Subject: **Docket No. 50-206**
Responses to NRC Questions on Intake Structure Degradation
San Onofre Nuclear Generation Station, Unit 1 (TAC No. 74168)

RESPONSES TO THE NRC'S "REQUEST FOR ADDITIONAL INFORMATION
RE: INTAKE STRUCTURE DEGRADATION
SAN ONOFRE NUCLEAR GENERATION STATION, UNIT 1
DOCKET NO. 50-206"

Fig. 3 - VARIATION OF CHLORIDE CONTENT WITH DEPTH

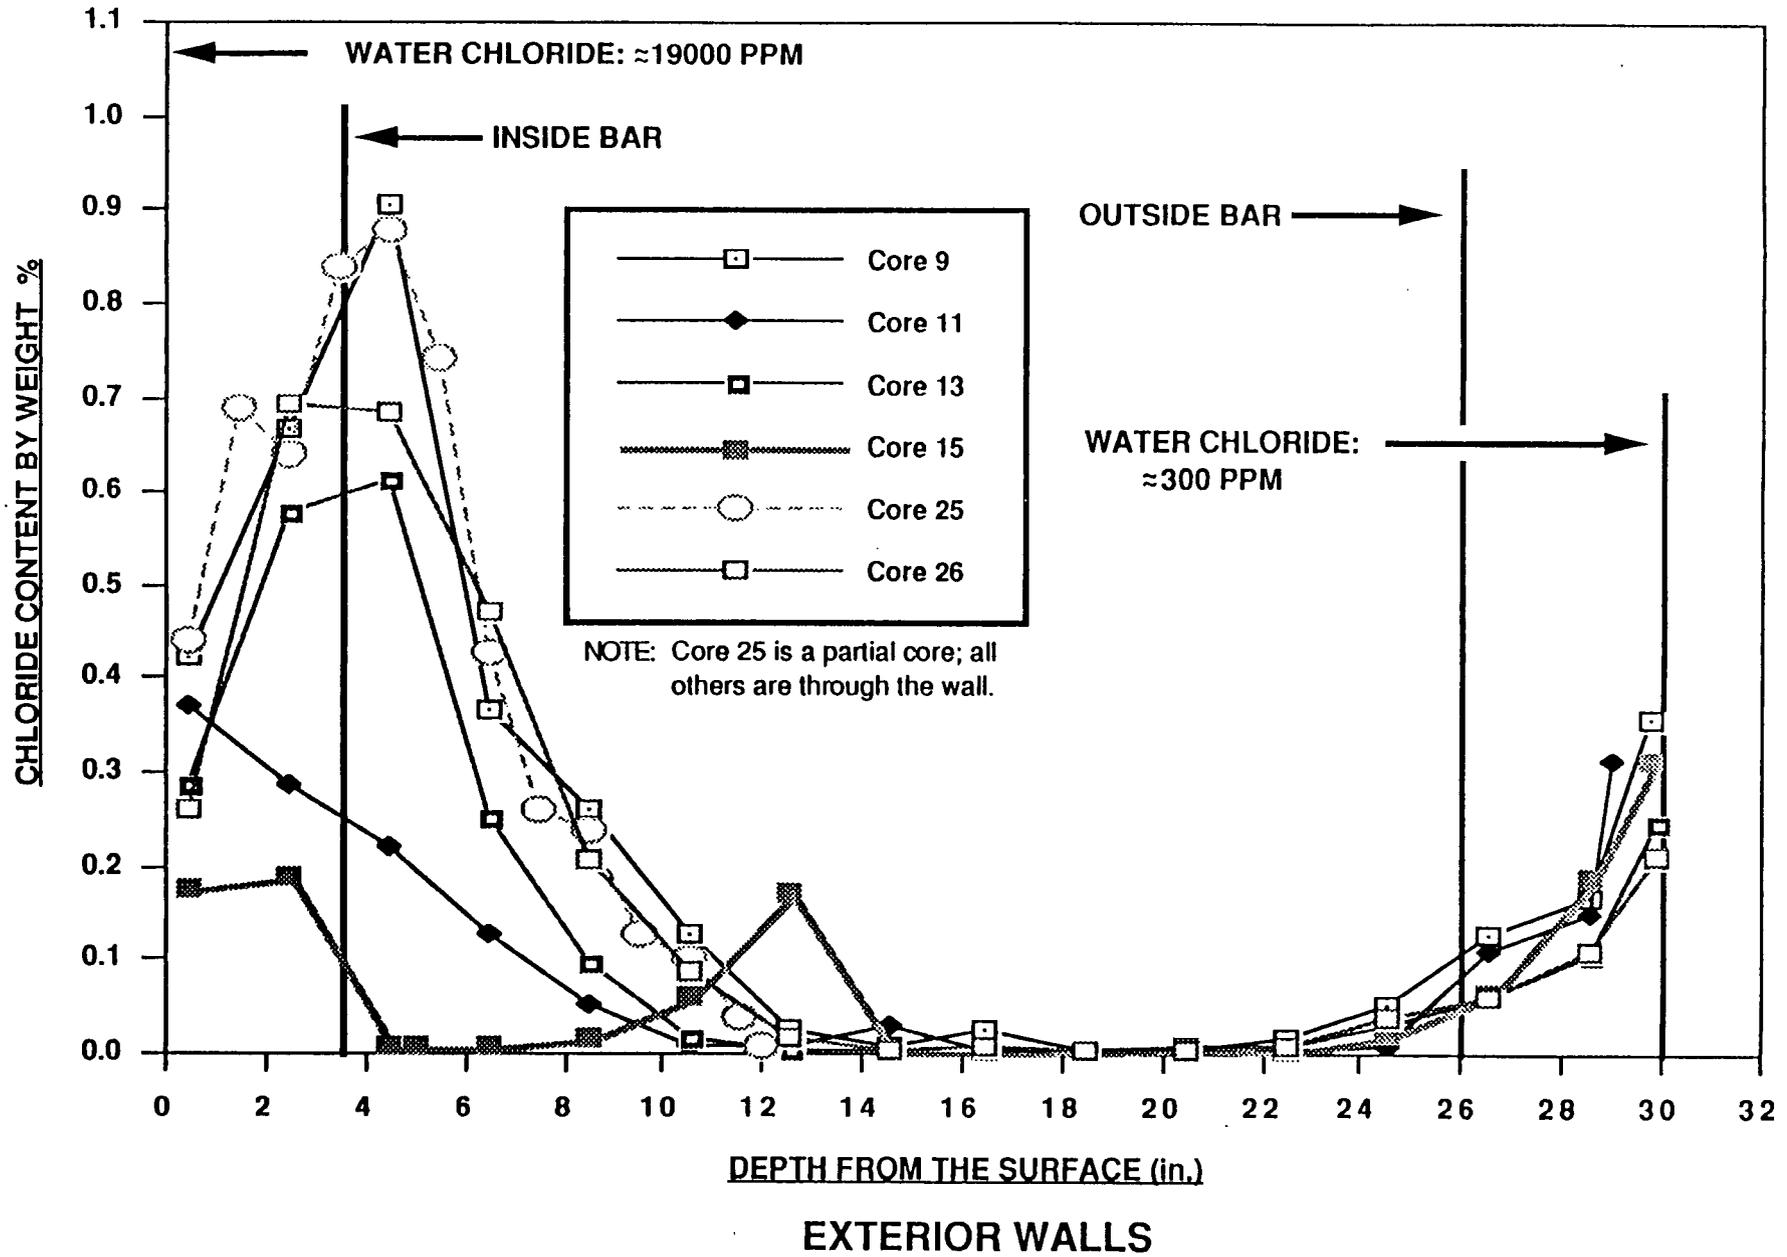
Cores 27, 28, and 29 were taken on the south wall of the south pump bay and south screen well (Figure 4). These cores represent chloride concentrations in concrete that is exposed to sea water on both sides (intake on the north side and discharge on the south side of the wall). The relatively high chloride content measured at both the inside and outside rebar of the south wall indicate that corrosion could be occurring on both surfaces. The inspection of the discharge side of the south wall showed only minor signs of corrosion during the Cycle 11 outage. In contrast, the north side of the wall exhibited many indications of corrosion. As previously stated, the north side of the wall was repaired in 1984. The difference in the degree of corrosion on the north side is attributed primarily to the higher sea water oxygen levels caused by pumping turbulence in the pump bays.
